Villages of Milano Phase 2 **Petition Number: 16-1PP**

Staff Report

Applicant: Neal Communities of SW FL, LLC. **Parcel ID #:** 0392-00-1000

MAP5: VICA PUD Approved Binding Master Plan

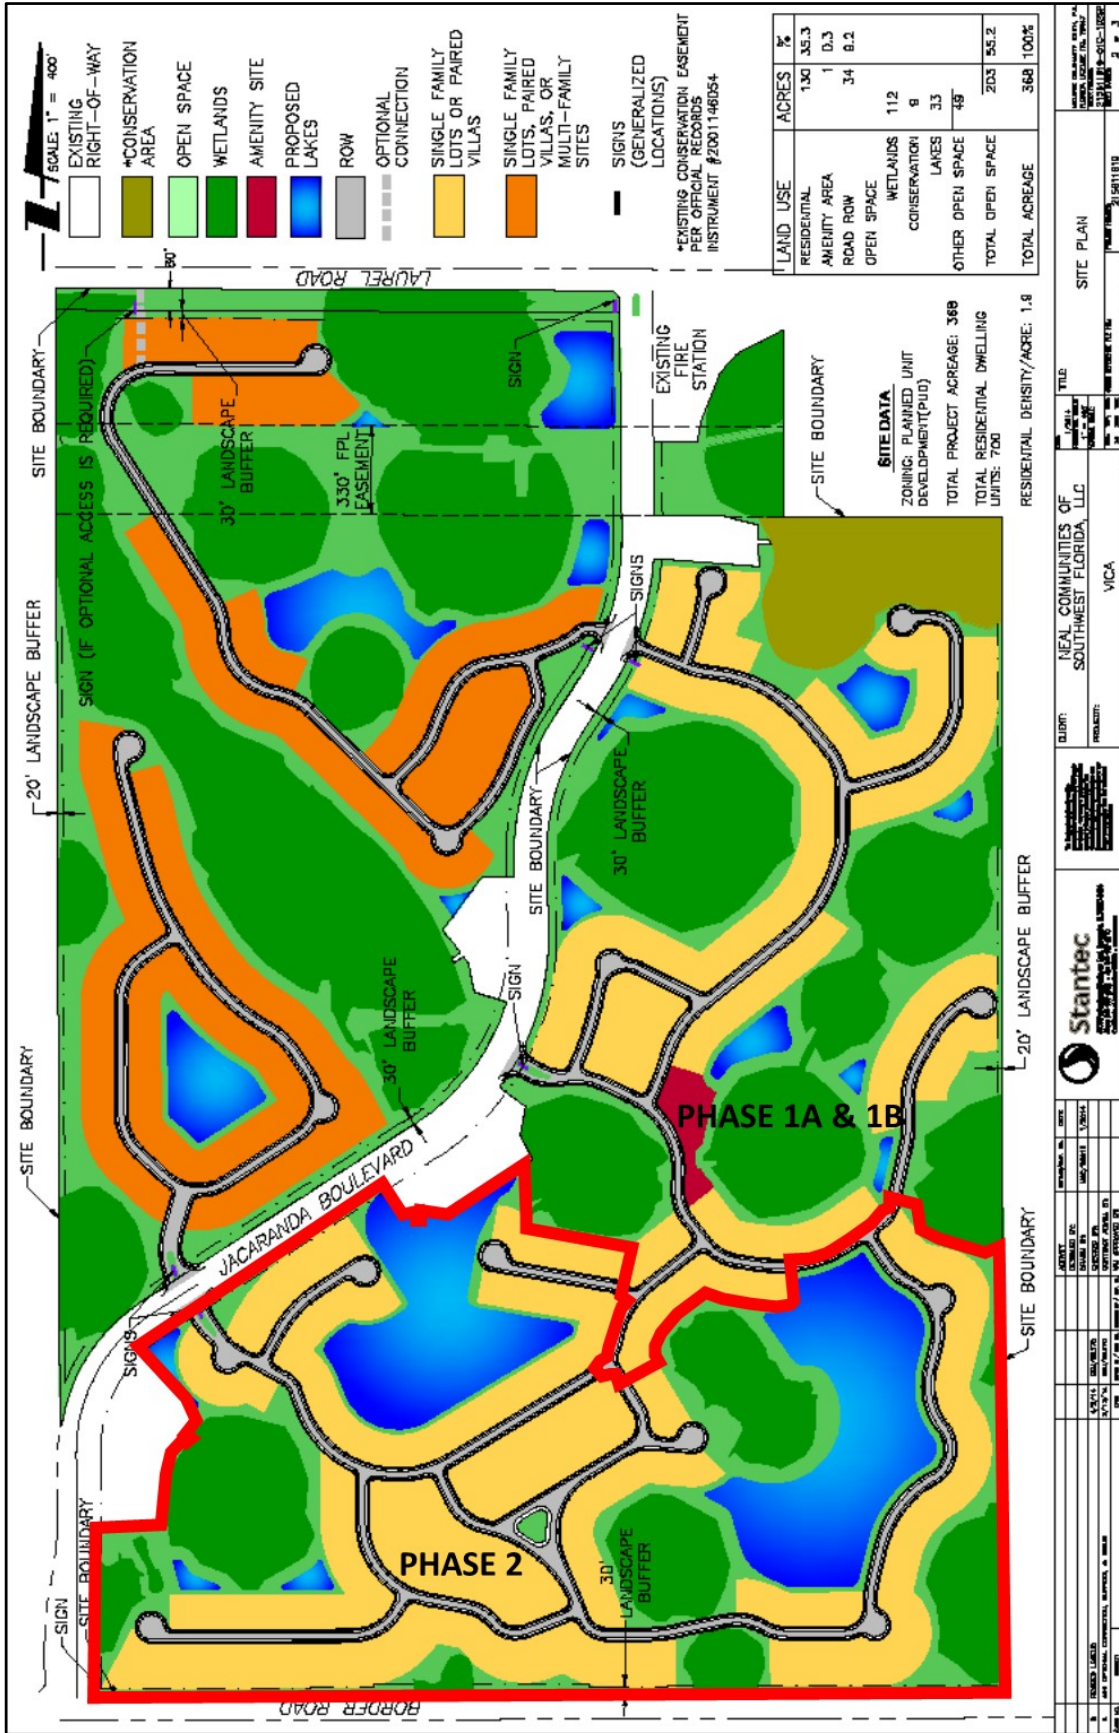
The design of any preliminary plat is required to be generally consistent with the VICA Binding Site Plan (See Map 5), which is the case for the Phase 2 preliminary plat. There is one difference between the proposed preliminary plat and the binding master site plan is the design of a portion of an internal private street in the southeast portion of the preliminary plat. On the binding master plan the street in question (Casalino Drive) is laid out along the eastern side of a stormwater pond with area for residential lots only on the east side of the street resulting in the street being located between the residential lots and the stormwater pond. The preliminary plat shifts the private street to the east which results in the rear of residential lots having frontage along the stormwater pond. The proposed design provides a water-front amenity to over 25 paired villa lots while maintaining the required landscape buffer and other open space along the eastern boundary of the VICA PUD.
